Addendum #4

Date: June 5, 2024

Project Name APMT Phase IV Yard Expansion

Project # 11261

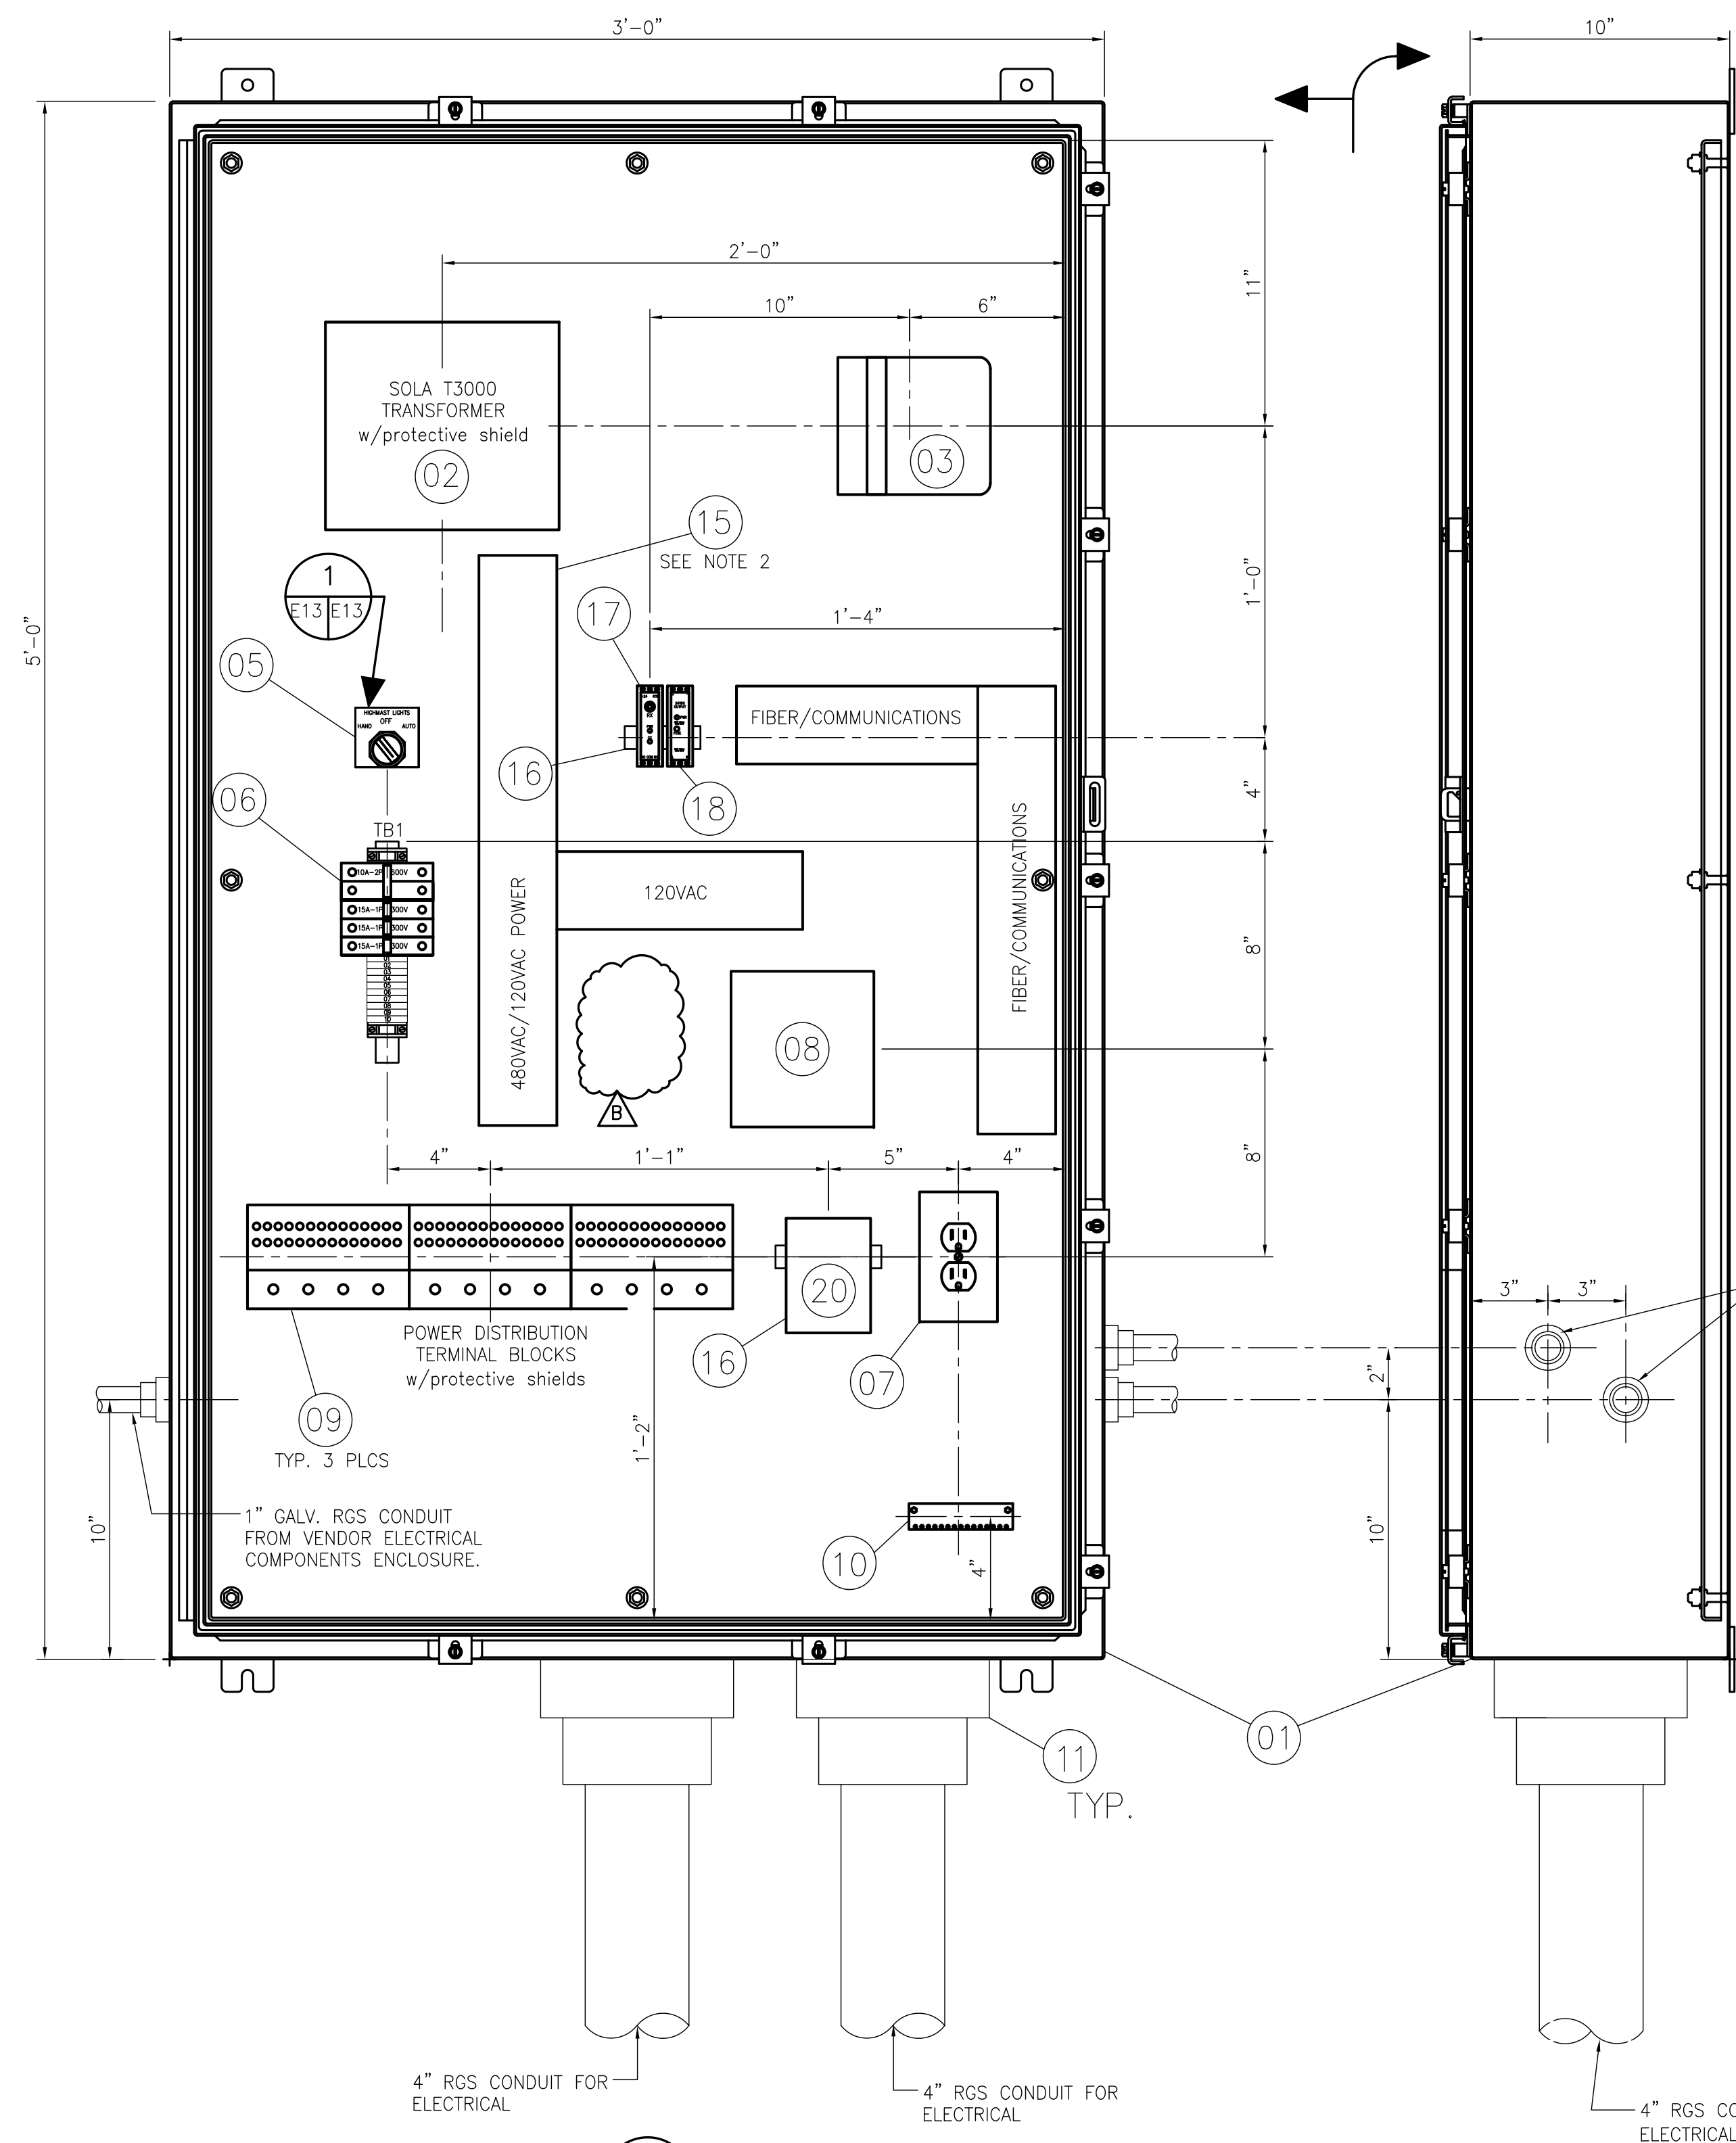
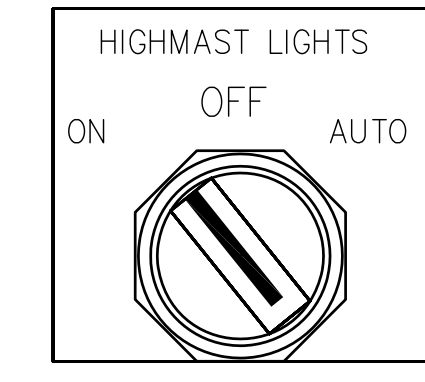
NOTES	NO.	REVISION	DATE	DRAWN	CK'D	APPD
	B	REVISED FOR BID - LIST OF MATERIALS ITEMS 18 AND 24	06/05/24	WMB	MED	RSG
	A	ISSUED FOR BID	04/05/24	WMB	MED	RSG

MARK	DESCRIPTION
01	60"x36"x12" 316 STAINLESS STEEL NEMA 4X ENCLOSURE HOFFMAN MODEL, A60H3612SS6LP. W/ALUMINUM BACKPANEL A6036P.
02	3kVA OPEN TYPE TRANSFORMER 480V/120V SOLA, MODEL T3000 WITH PROTECTIVE SHIELD
03	FIBER OPTIC SPLITTER BOX - MANUFACTURED BY BLACK BOX.
04	(NOT USED)
05	THREE POSITION SELECTOR SWITCH MAINTAINED POSITION. (2) N.C. AND (2) N.O. CONTACTS, ALLEN BRADLEY MODEL 800T-J2B. WITH 800T-X-700E NAMEPLATE THAT READS AS SHOWN ON DRAWING.
06	TERMINAL BLOCK "TB1" CONSISTING OF: (1) 10A-2P, 480V CIRCUIT BREAKER - ALLEN BRADLEY MODEL 1492-SP-2-D-100. (3) 15A-1P CIRCUIT BREAKERS - ALLEN BRADLEY MODEL 1492-CB-1-H-100-N. (10) TERMINAL BLOCKS - ALLEN BRADLEY MODEL 1492-F1 TERMINAL MOUNTING RAIL - ALLEN BRADLEY 1492-N22 END BARRIER - ALLEN BRADLEY MODEL 1492-N18. END CLAMPS - ALLEN BRADLEY MODEL 1492-N2.
07	15A 120V, GFCI RECEPTACLE FLUSH MOUNTED INSIDE OF ENCLOSURES. PROVIDE ALUMINUM WEATHER PROOF COVER. SHALL NOT BE A GFCI TYPE IN COMMUNICATIONS ENCLOSURE.

08	30A-3P, OPEN TYPE ELECTRICALLY HELD LIGHTING CONTACTOR W/AUX. CONTACTS. 120V COIL. ALLEN BRADLEY MODEL 500FL-B0D93
09	POWER DISTRIBUTION BLOCKS - ILSCO TYPE PDBU CAT. NO. PDBU-428-500-1 W/PROTECTIVE SHIELD
10	GROUND BAR
11	GALV. RAIN TIGHT HUB TYPICAL
12	(NOT USED)
13	(NOT USED)
14	(NOT USED)
15	3"x3" PANDUIT WIRING DUCT WITH COVERS, SEE NOTE 2 THIS DRAWING
16	35 MM DIN RAIL, ALLEN BRADLEY CAT. NO. 199-DR1., AS REQUIRED
17	FIBER OPTIC RECEIVER FOR-CC-850-MM-ST
18	24V DC POWER SUPPLY, DIN RAIL MOUNTED. WEED INSTRUMENT PSM-CC-B
19	FIBER OPTIC CAMERA & SECURITY EQUIPMENT BY BLACK BOX. INSTALL IN COMM. ENCL. (BY OTHERS)
20	30A-3P CIRCUIT BREAKER ALLEN BRADLEY MODEL 1492-MC-BA330.
21	UNINTERRUPTIBLE POWER SUPPLY (UPS). INSTALL IN COMM. ENCL. (BY OTHERS)
22	FIBER OPTIC TRANSMITTER FOT-CC-850-MM-ST. INSTALL IN APMT SERVER ROOM
23	1M FIBER OPTIC CABLE. (SEE DWG. 4484-E21 PERIMETER LIGHTING AND CONTROL DIAGRAMS)

24	(NOT USED) B
25	COMMUNICATIONS ENCLOSURE, NEMA 4, HOFFMAN CAT# CSD363020 WITH BACK PANEL

PHOTOGRAPHS

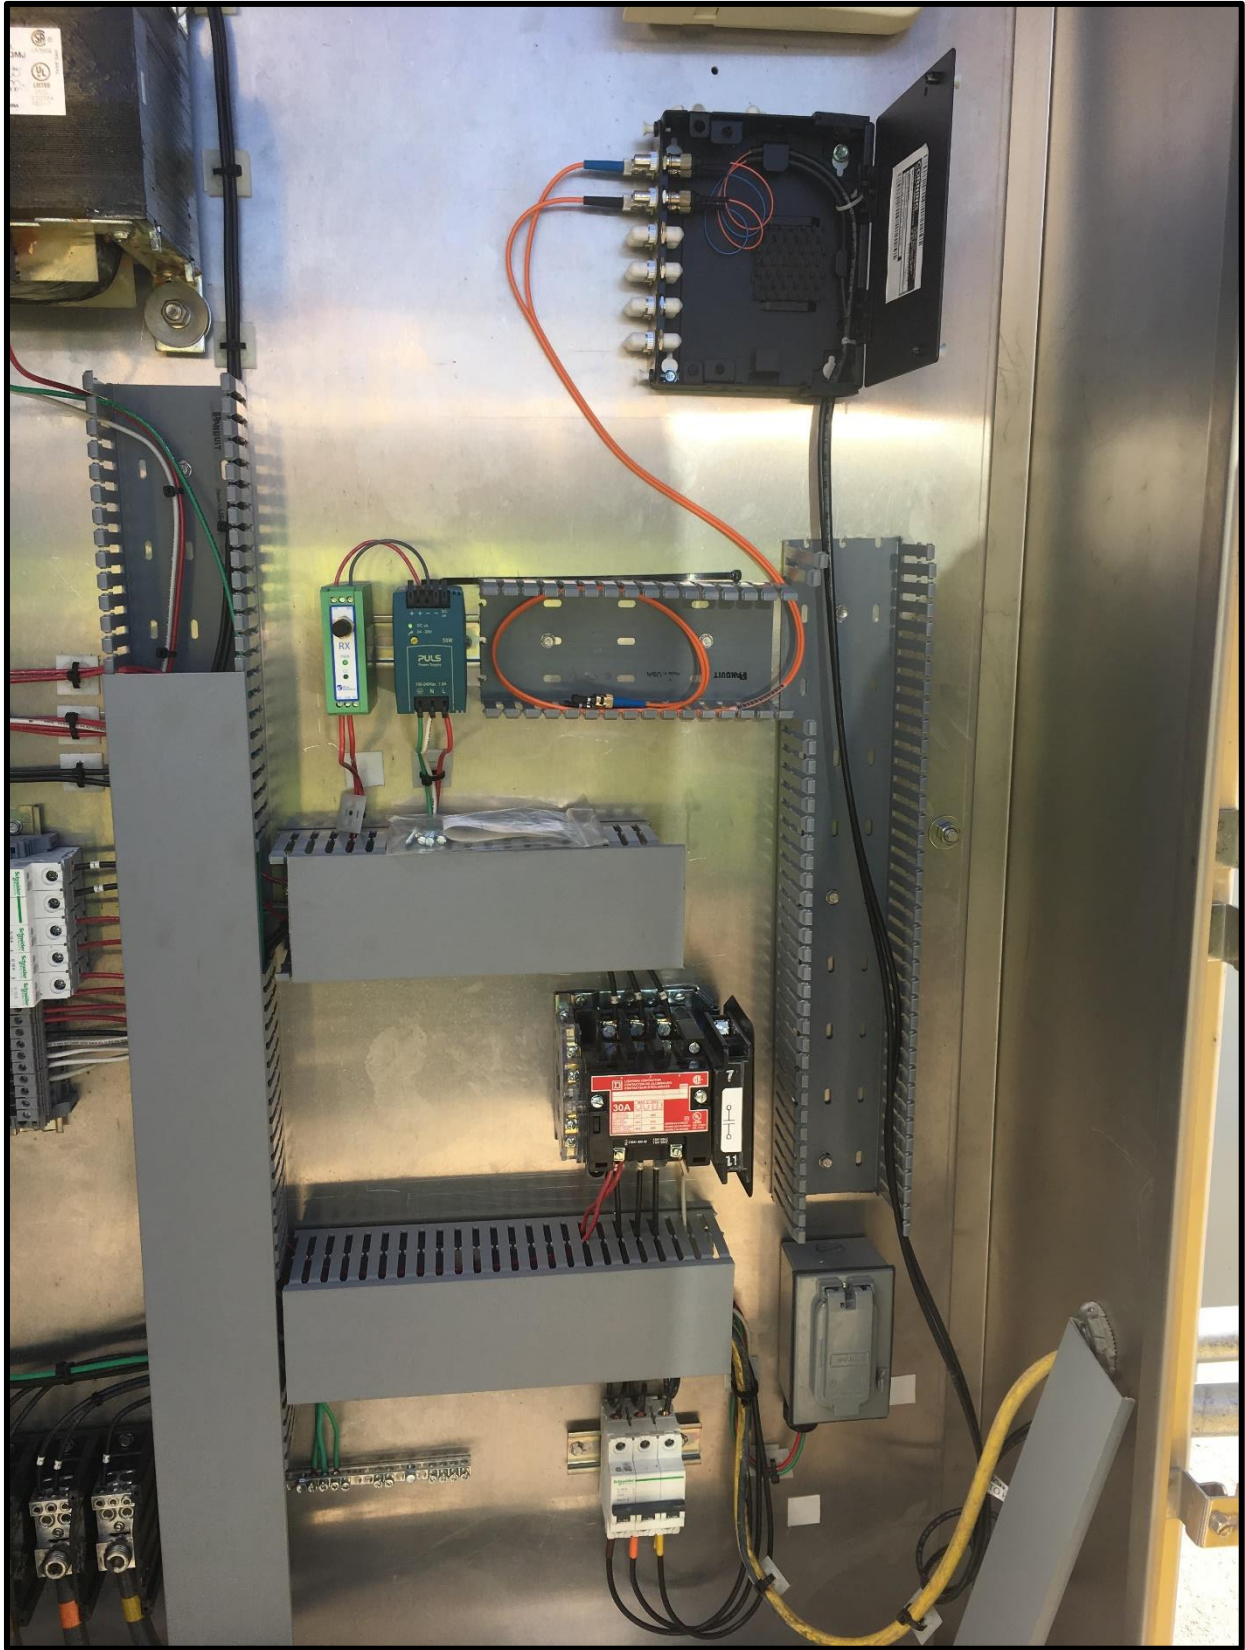
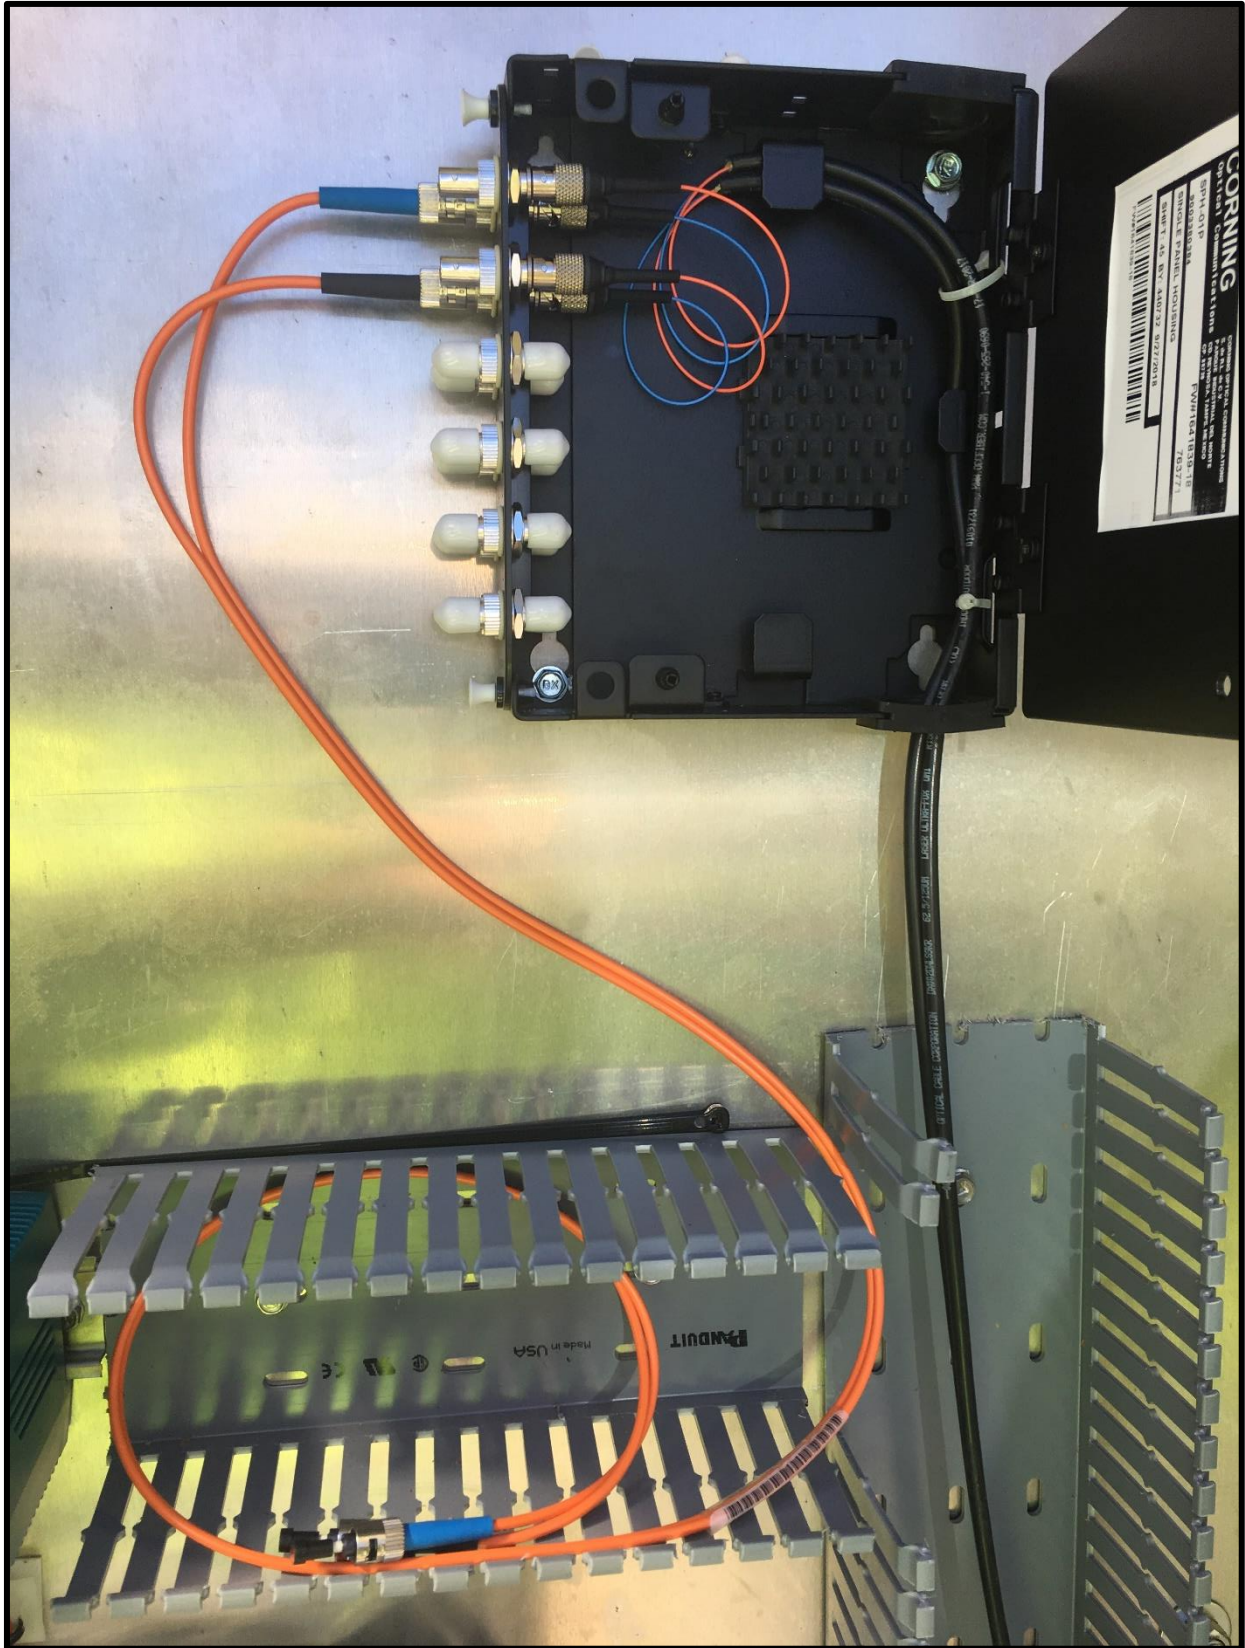
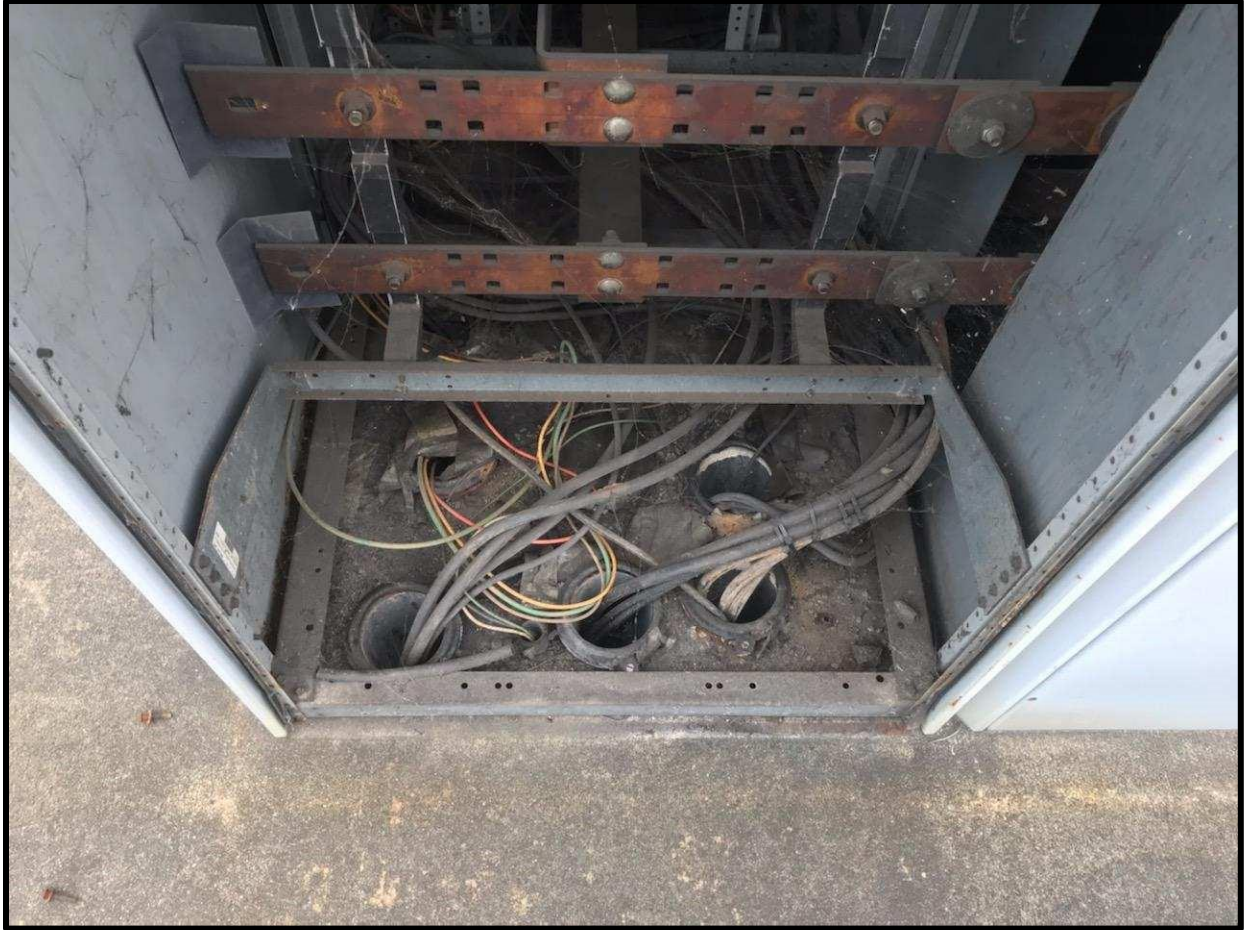
20.	<p>Can pictures be provided for the following? Lighting controls hardware in the Admin Building. Sub 4 and Sub 5 switchboards. Lighting controllers in high mast light poles. Answer: Admin pictures are unavailable. Available pictures of lighting controllers and switchboards are attached.</p>
